## COUNCIL ASSESSMENT REPORT

<b>Panel Reference</b>	<b>PAN 248325 &amp; PPSSEC-216</b>
<b>DA Number</b>	<b>DA-2022/237</b>
<b>LGA</b>	<b>Bayside</b>
<b>Proposed Development</b>	(As Amended) Integrated Development - Demolition of existing structures and construction of a six (6) storey mixed-use development comprising retail uses, hotel accommodation, food and drink premises, basement carparking, tree removal and signage zones
<b>Street Address</b>	277 The Grand Parade, Ramsgate Beach, NSW
<b>Applicant/Owner</b>	Moside Pty Ltd
<b>Date of DA lodgement</b>	10 August 2022
<b>Total number of Submissions</b> <b>Number of Unique Objections</b>	<ul style="list-style-type: none"> <li>• 32+23+19 (3 notifications, 80 total)</li> <li>• 31+22+18 (Unique, excluding residents who submitted during each exhibition period)</li> </ul>
<b>Recommendation</b>	<b>Refusal</b>
<b>Regional Development Criteria (Schedule 7 of the SEPP (State and Regional Development) 2011)</b>	<b>Part 2 – General Development Over \$30M</b>

The development application (“DA”) has been assessed in accordance with the relevant requirements of the *Environmental Planning and Assessment Act 1979* (“the Act”), associated *Environ

**Figure - Overshadowing plans – 2pm and 3pm midwinter**

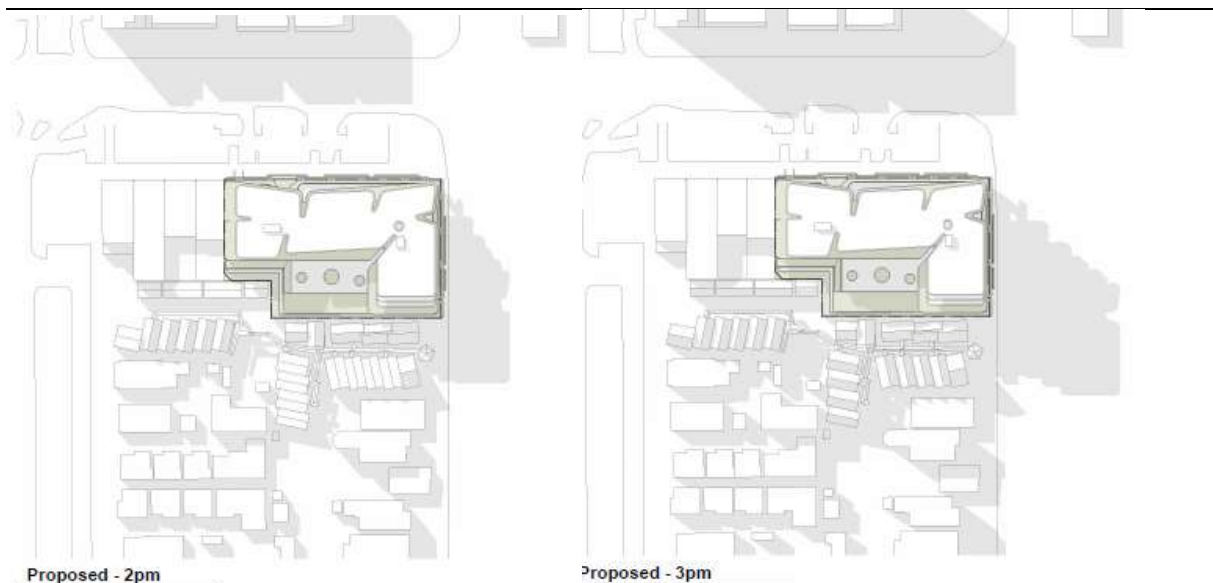
In terms of overshadowing, Cook Park only becomes overshadowed by the proposal at around 2.30-3.00pm in mid-winter. This is linked to height non-compliance, and while the time of impact does not align to periods of peak usage of the park, this is still a negative aspect of the proposal.

**Figure - Rooftop signage zones**

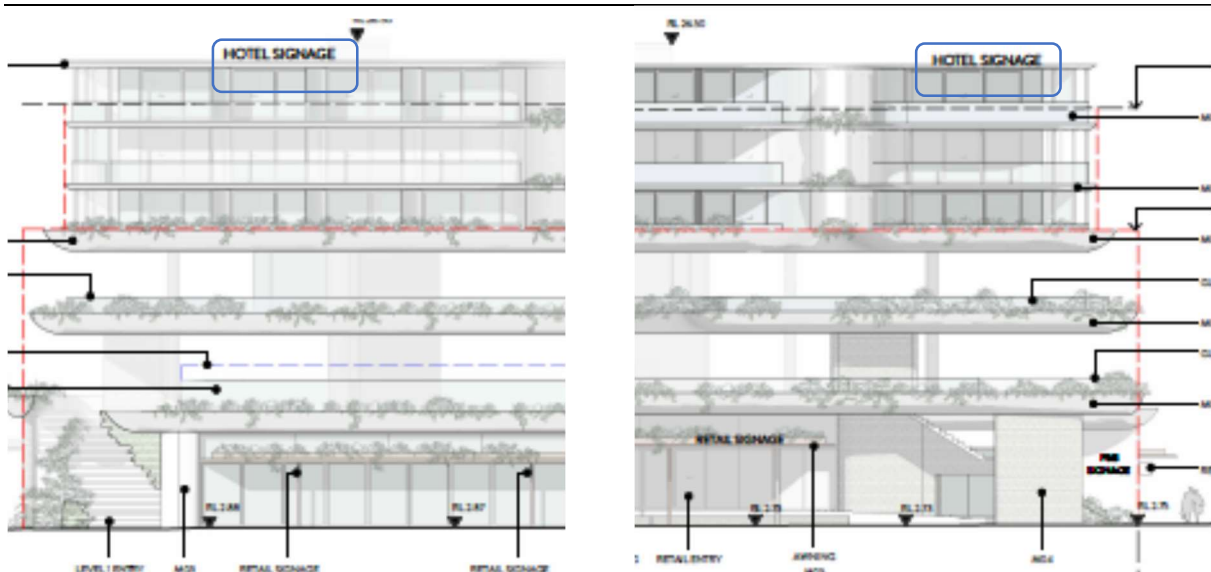
Technically, the signage zones do not need assessment against Schedule 5 of the SEPP. However, concern is raised with the proposed roof signage, which would detract from the design and as it is inappropriately-placed (highlighted on the elevation extracts below). These signage zones are not supported, although this is not a critical aspect to the proposal and has not been included as a reason for refusal, as they could easily be removed by a condition if approved.

**Figure - Plan extracts – First Floor (top) and Second Floor relative to southern boundary**

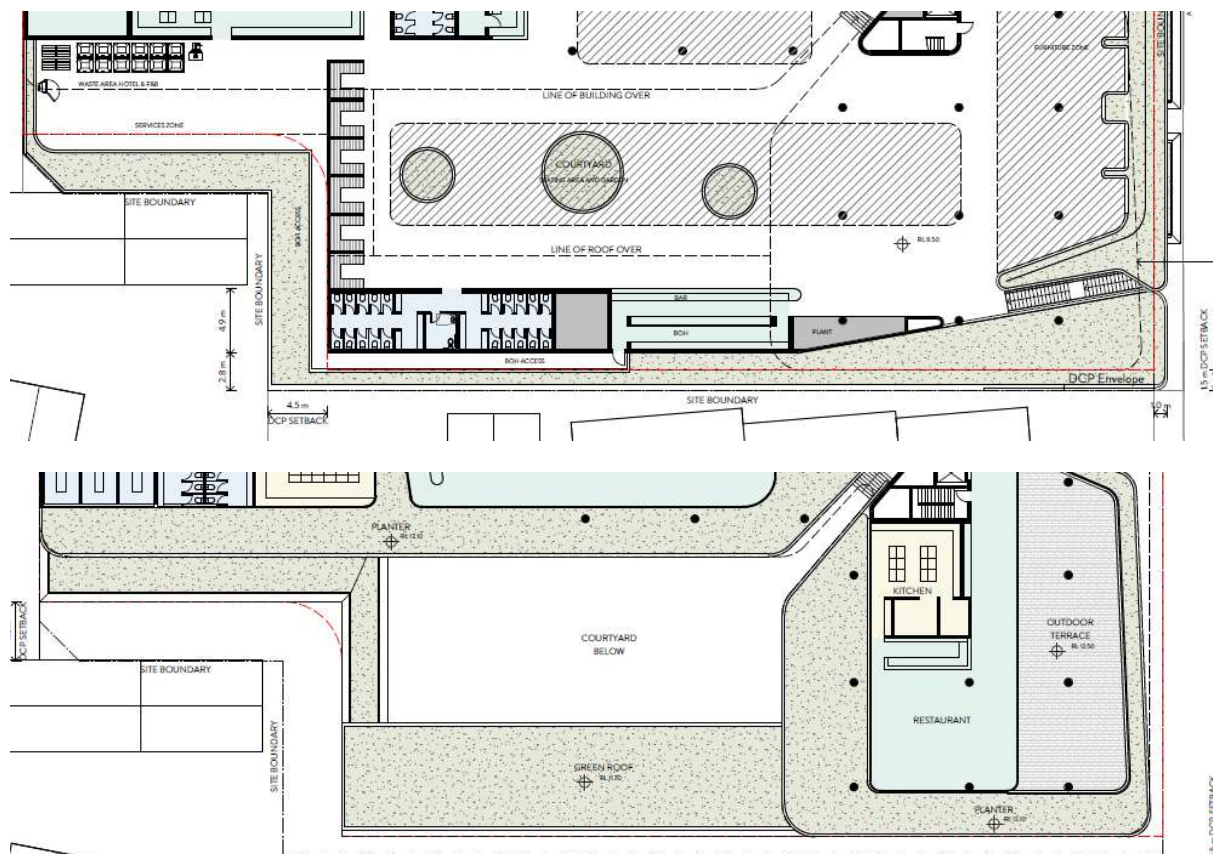
In terms of the open nature of the first and second floor relative to the southern boundary, this has been significantly improved in the most recent plans, compared to the original DA, with greater walls for shielding than previously proposed, and greater setbacks at the second floor to actively-used spaces.

However, the back of house access at first floor is close to the boundary and compromises greater landscaping, while the two storey “open” courtyard on Level 1 (under the building above), will lead to likely adverse acoustic impacts due to reverberation from the soffit. Similarly, the outdoor terrace to the east of the restaurant on Level 2 is close to the southern boundary and not enclosed. These areas have been excluded from Gross Floor Area (“GFA”) calculations.

The design at first floor could be amended to remove the back of house area/access, but the second-floor design, and non-compliance with the 24m southern setback at the upper levels (addressed in a subsequent section in response to the DCP controls), leads to an inappropriate land use interface with the site and the adjoining residential site/zoning to the south, and is therefore considered to be inconsistent with the third objective of the zone.

**Figure** – Ground Floor – Lobby and internal loading area

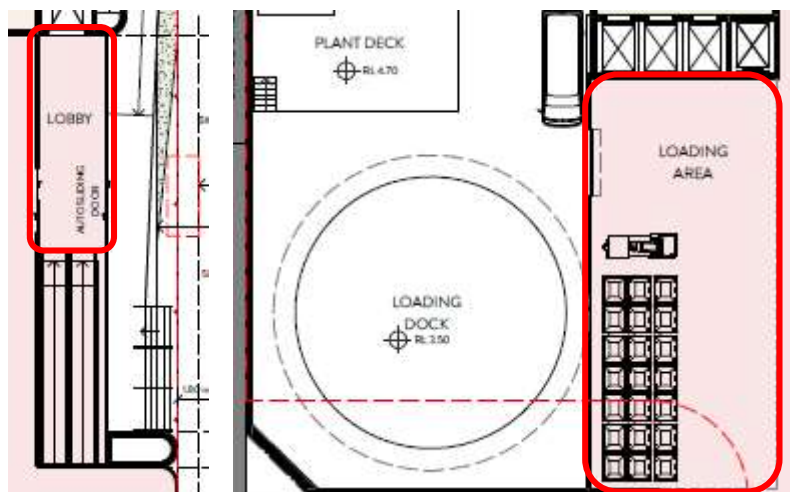
The loading dock and area off Ramsgate Road has been excluded (white below). This is appropriate.

The internal loading area adjoining the truck loading dock at the western end of the supermarket (shaded pink and labelled “Loading Area” below) could be argued to be *any space used for the loading or unloading of goods (including access to it)*. However, the area appears to be part of the supermarket and based on the design as shown, while also not beyond doubt, I prefer including that area as GFA.

**Figure** – First Floor plan, elevation and GFA calculation extracts

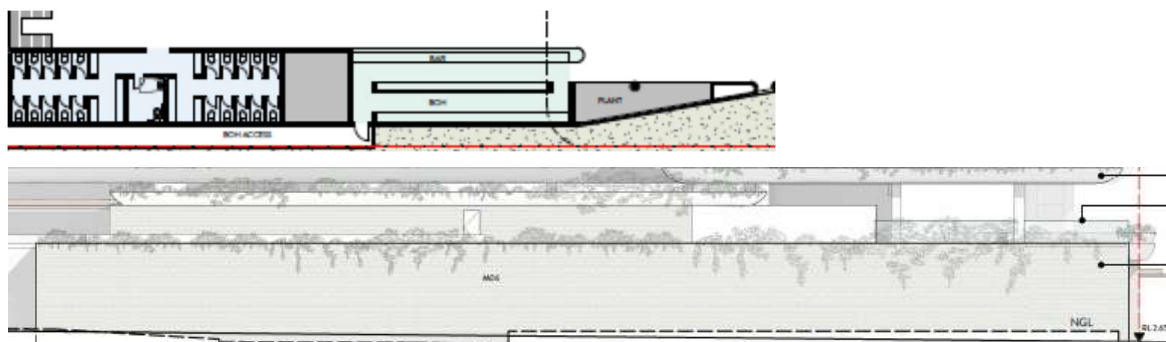
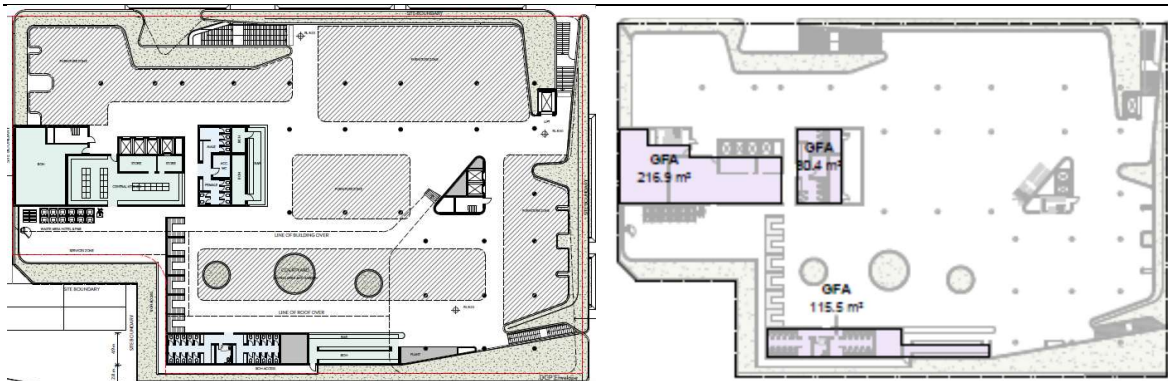
At the first floor (level 1), the areas warranting consideration are the southern bar and all the “undercroft area” not counted as GFA. While not fully enclosed, this area is surrounded by southern walls to the toilet bar and plant (assumed full height from the elevation and functional need) or noise attenuating measures (which constitute a wall, and walls may be glazed, in my view) of over 1.4m. The exact location of the acoustic screening is not clear on the plans, although screens at 1.5m are shown on elevations and well over that in the most recent acoustic report.

Only half of the southern bar area is included in GFA, which seems illogical and incorrect.

In terms of the remainder of the internal undercroft area (white in the GFA plan extract above), this should be included in GFA, in my view, given the enclosing southern wall and external enclosing acoustic walls being higher than 1.4m. However, part of this area (the two-storey void) may be appropriate to exclude as GFA as a void.

**Figure** – Second Floor plan and GFA calculation extracts

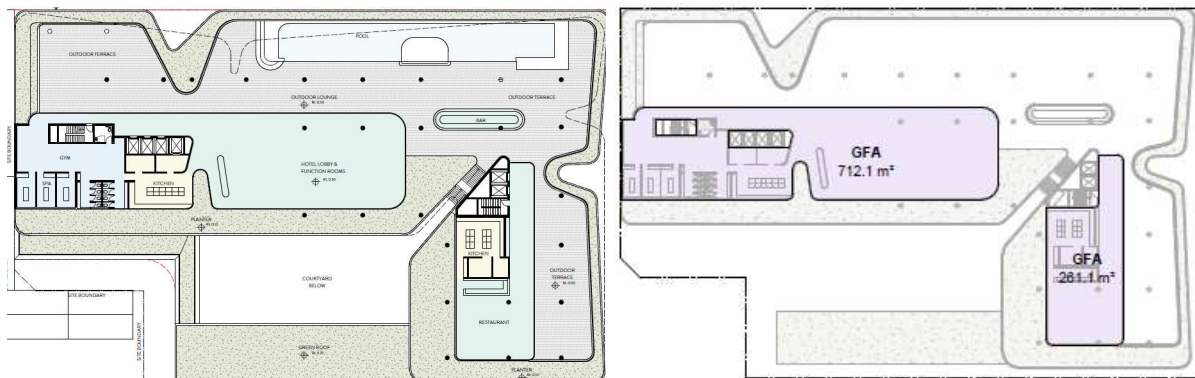
For the second floor, the same “undercroft” exclusion issue applies, for the white areas to the north and east of the areas included in GFA shown below:

**Figure** – Levels 3-5 GFA calculation plans

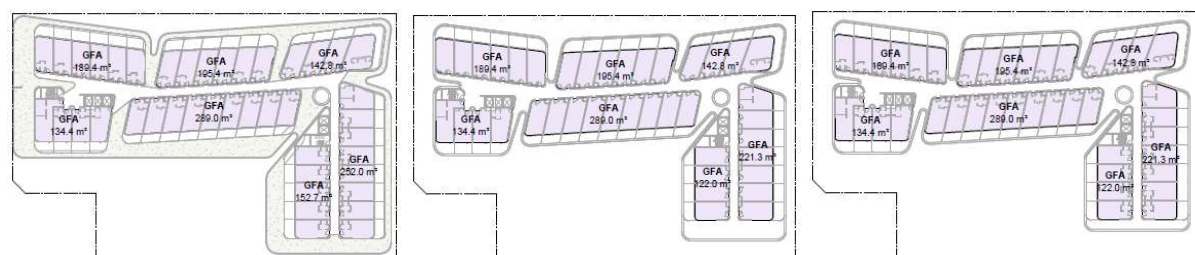
For levels 3-5, the areas warranting consideration are all essentially the same, being corridor areas. While not entirely clear, it is assumed that the balustrade height is 1m (or below 1.4m) for all the “ends” of the internal corridors. If so, this is questionable from a functional point of view given the exposed nature of the corner site, particularly to wind and rain from the south, south-east and north-east. In any event, the prevailing nature of these spaces is considered to be internal, due to the location of hotel rooms on both sides. In my view, these internal corridor areas are essentially shielded from the outside elements and are internal, and should be included as GFA.

**Figure** – extract of height non-compliance in Clause 4.6 request

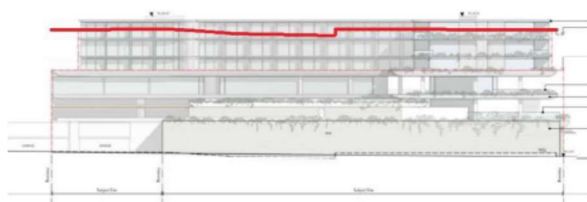
As previously outlined, the applicant is seeking to contravene the 20.5m Building Height development standard by 3.14m, representing a two-dimensional 15.4% non-compliance. This is to the top of the two lift motor rooms on the roof. The height of the remainder of the non-trafficable roof is 23m (using a ground level of 2.5m), which contravenes the 20.5m Building Height development standard by 2.5m, representing a two-dimensional 12.2% non-compliance.

**Figure** – Survey Extract highlighting applicant’s nominated rear boundary (red)

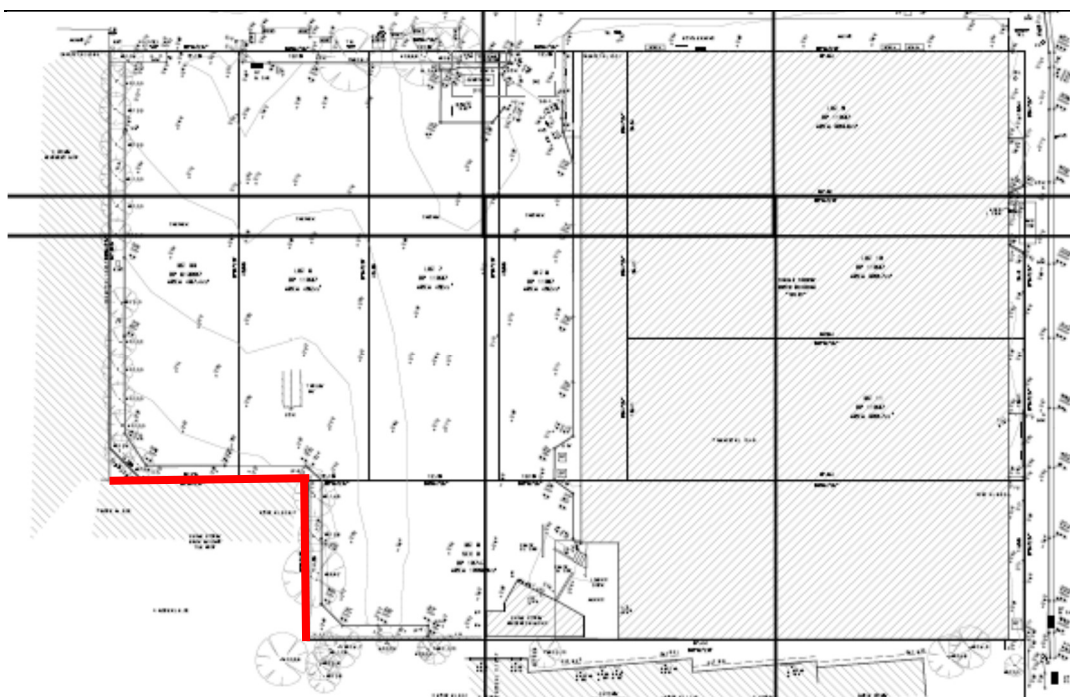
- This matter and control gives rise to the characterisation of what the "side" and "rear" boundaries of the site are. The applicant argues that the front boundaries are those to both street frontages (which is accepted), the side boundaries are those perpendicular to the front boundary (being the western and southern boundary) and the rear boundary is the southern and western "kink" in the boundary, parallel to the front boundaries, as shown in red below:

- There is a different view that the southern boundary is the rear boundary. The main argument supporting this is that the site essentially fronts Ramsgate Road (the wide boundary), the entrance is to Ramsgate Road and the DCP implies the southern boundary is the rear, on the southern side of Ramsgate Road. This is the view held by Council staff and expressed at pre-DA advice.

**Figure – Level 3 and West Elevation**

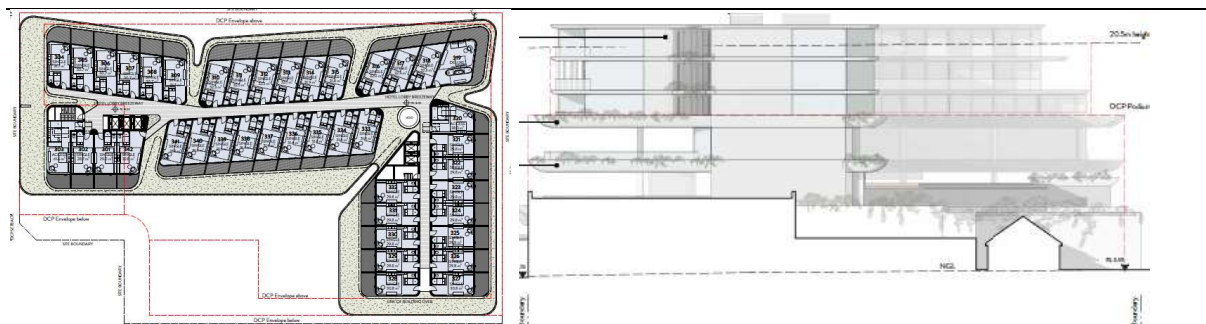
The design has considered visual impacts to the south at lower levels due to building to the side boundary with no openings and landscaped setbacks at the two upper levels. However, the non-complying southern setback at the upper levels of the building adds to adverse privacy impacts. At Level 3, it would be important to ensure the landscaped edge around the hotel building was not accessible to users of the building (with potential hatches for maintenance). Similarly, the southern edge of balconies of the southern-most hotel rooms should be screened.

There is a potential privacy issue to the west, particularly as this portion of the building well exceeds the minimum 24m southern setback at upper levels. This has been largely considered by blank walls, although side screening to rear terraces would also be warranted.

**Figure – Top two levels**

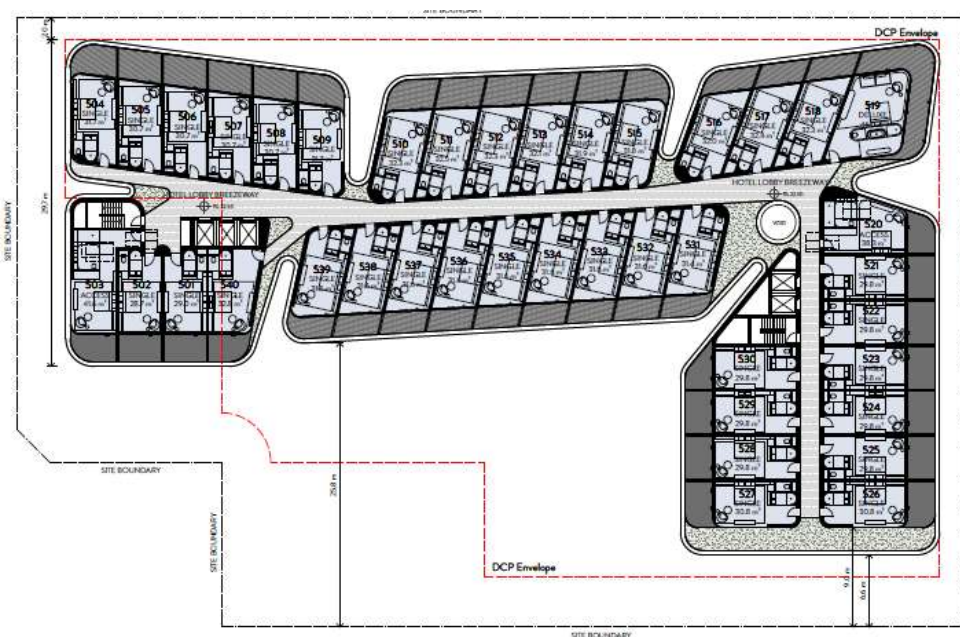
At the upper two levels, the key privacy concern is the southern privacy (and visual) interface with the portion of the building fronting The Grand Parade, within the 24m southern setback control. There is a landscaped bed shown, which may be effective, depending on planting, soil depth and ability to withstand southerly salt-laden winds.

The size of balconies for hotel rooms (particularly given the room sizes) is generous. For the rear-facing central balconies, an edge landscaped planter bed should be provided and would be consistent with the design, and reasonably reduce privacy and visual impacts to the south.
